Floor plans. General arrangement.

SHDC
PLANNING & DEVELOPMENT
- 3 JUL 2007
Ref. 0895/07

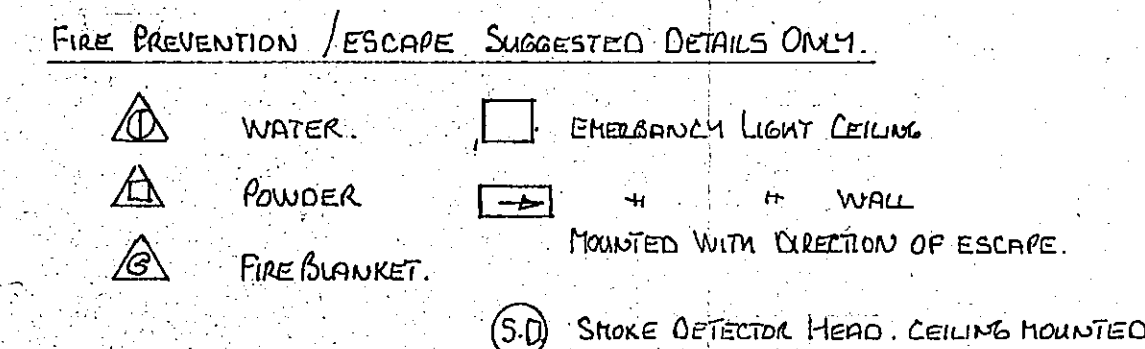
ADDITIONAL EMBLEMATIC LIGHTING SHOWN FOR 6LO FLOOR.
DAMP RESISTANCE DETAILS NOTED.
MAIN DOOR SIZE INDICATED.
EXTRACT FAN FOR INTERNAL W.C. ADDED
S/DETECTORS ADDED DOWN UPPER LANDING & LOWER
CORRIDOR AT TOP OF 1ST. FLOOR. S/CASE.
GLAZING TO WINDOWS IN ABSET PASSAGE
NOW TO BE 1/2" RATED.

B A/C. UNITS MOVED TO ROOF STILLAGE AT
REAR OF BLO. JUNE 2007.

C SHOP FRONT NEW DSG. NOTED. JUNE 2007
